September 4, 2014

**Subject: Convenience Store and Fuel Station Development – 2282 Congress Street**  
**Applicant: Portland Property Holdings, LLC**  
**Response to Ben Viola’s Review Comments Dated August 22, 2014**

FILE NAME: 3118-SP  
SHEET: C-14.1

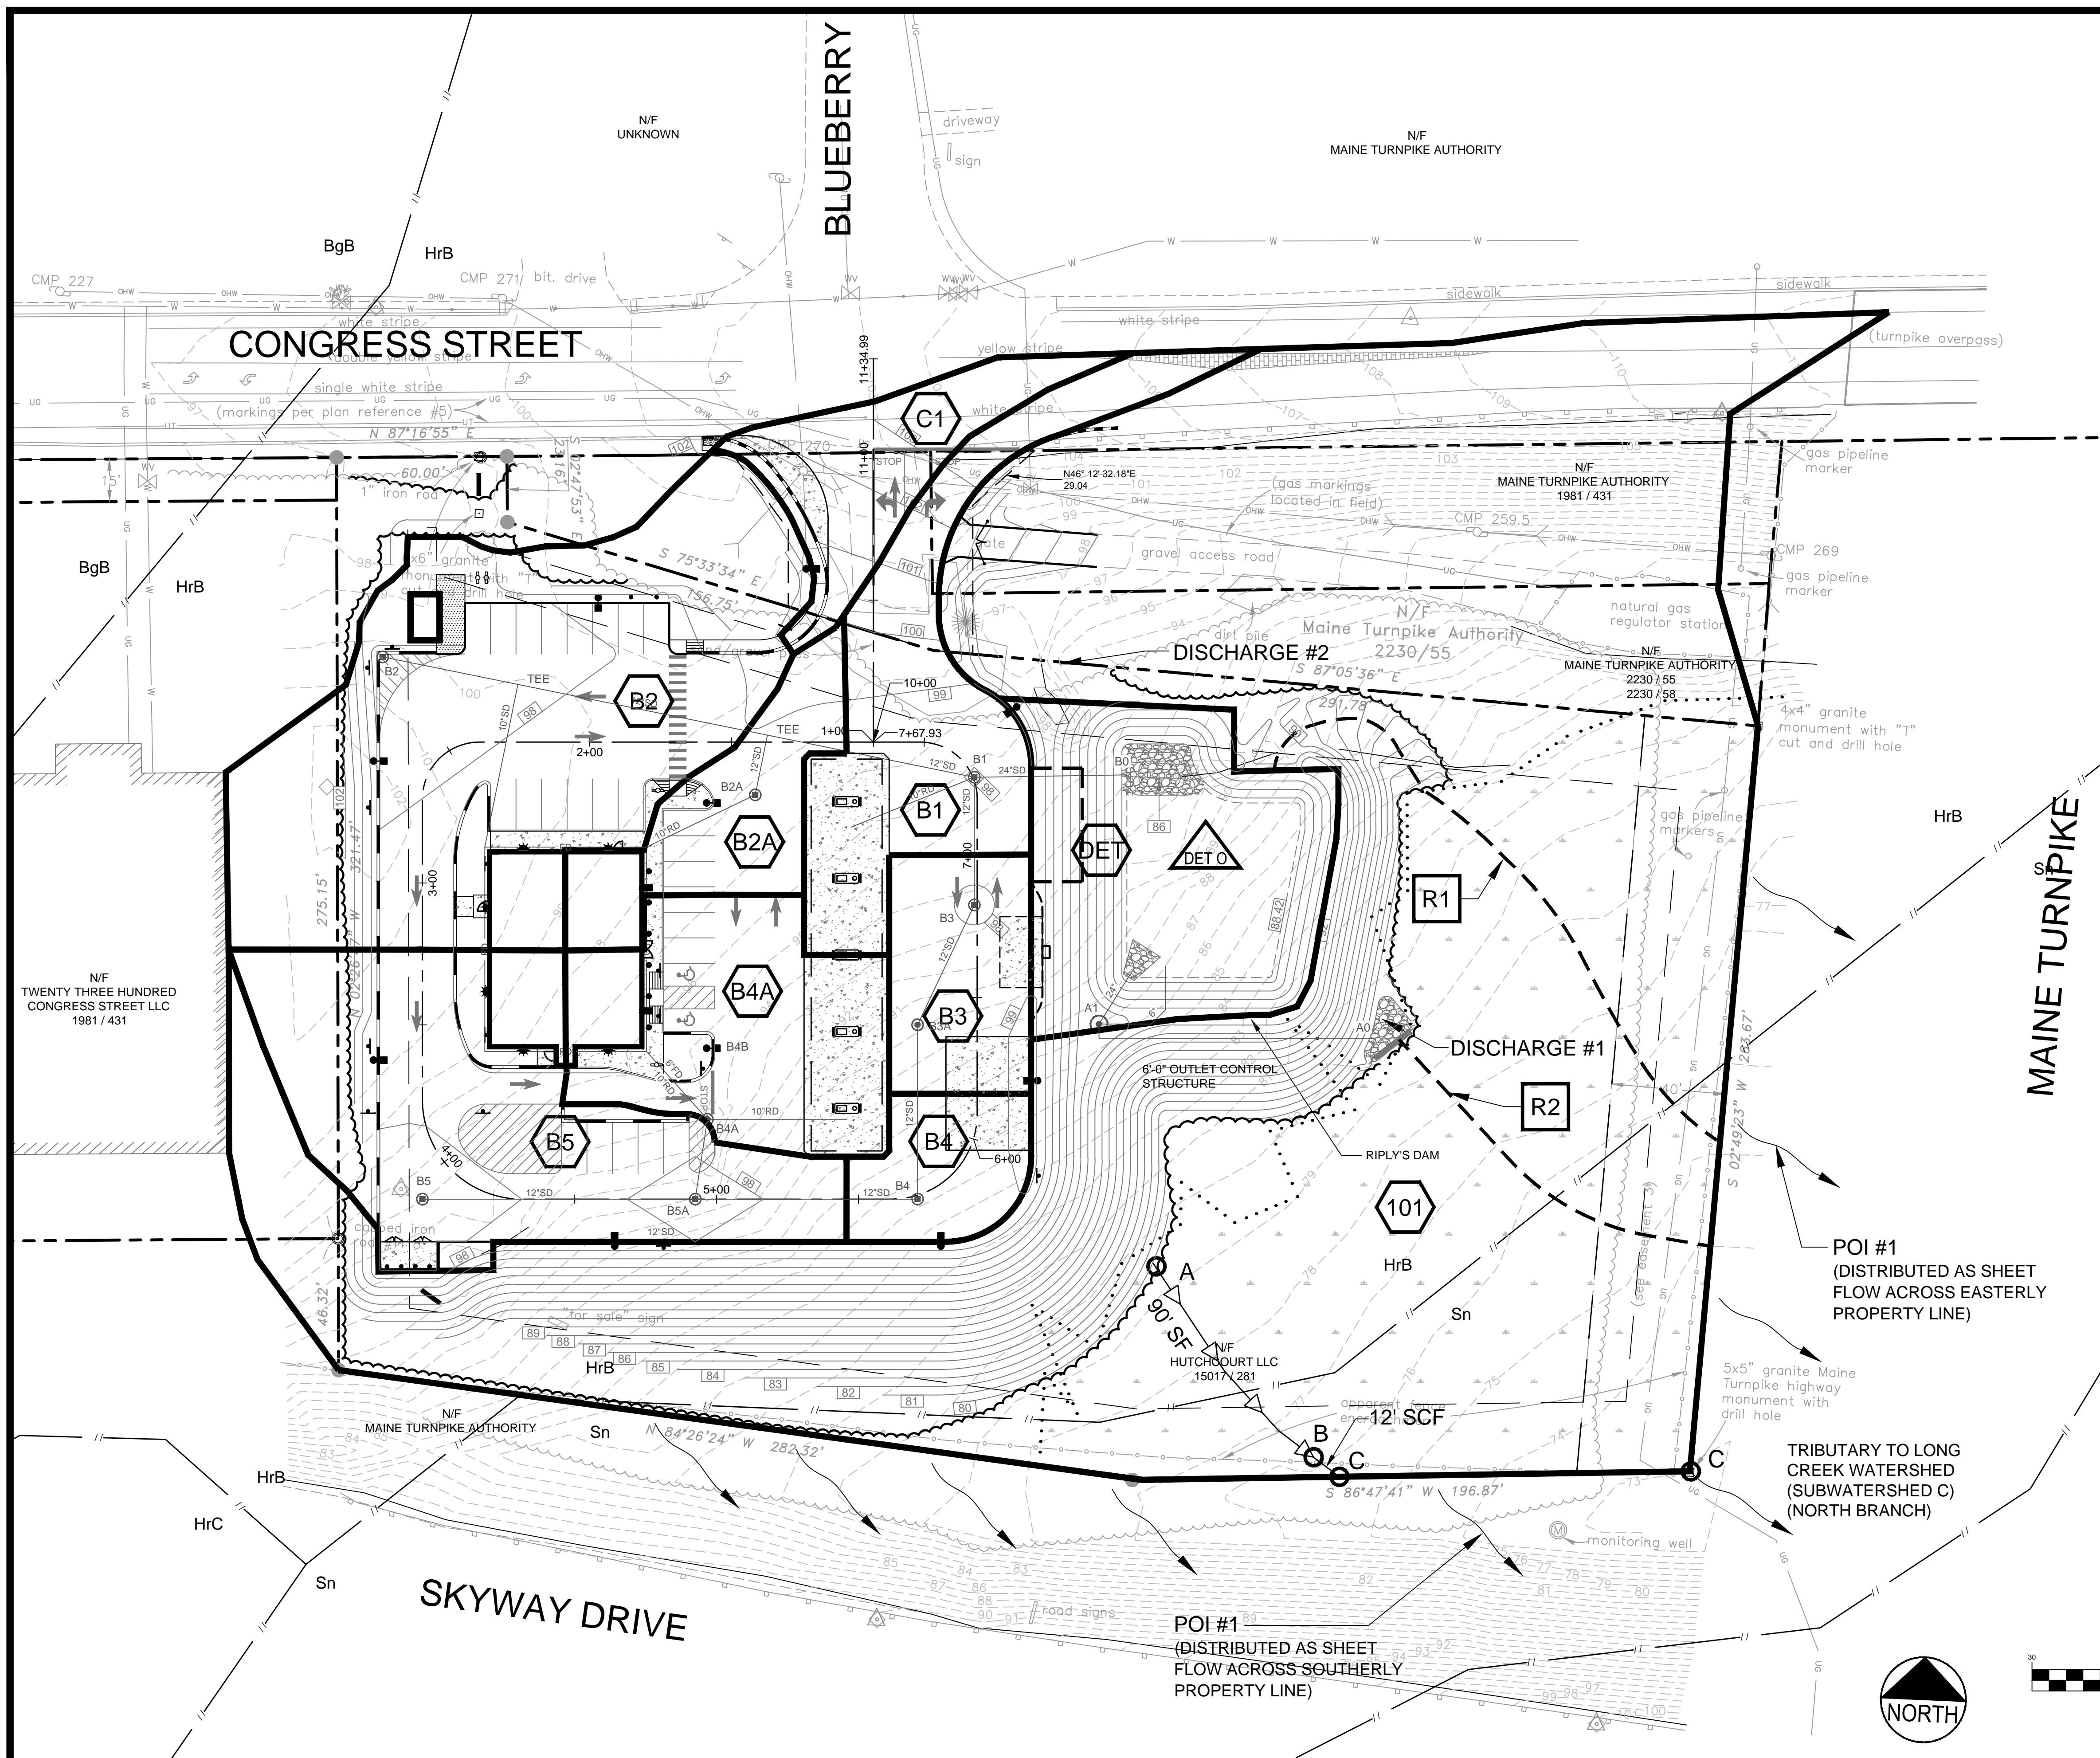
*Sheet C-14.1:*

- *Please add time of concentration flow line to the plan view.*

Time of Concentration (Tc) flow lines are shown on Sheet C-14.1 where applicable. As noted on the plan, watersheds without a Tc drainage flow path defined are assumed to have the minimum Tc of 6 min. as recommended in the TR-55 Manual. Any flow path within the watershed has a Tc less than 6 min. and therefore does not need to be shown.
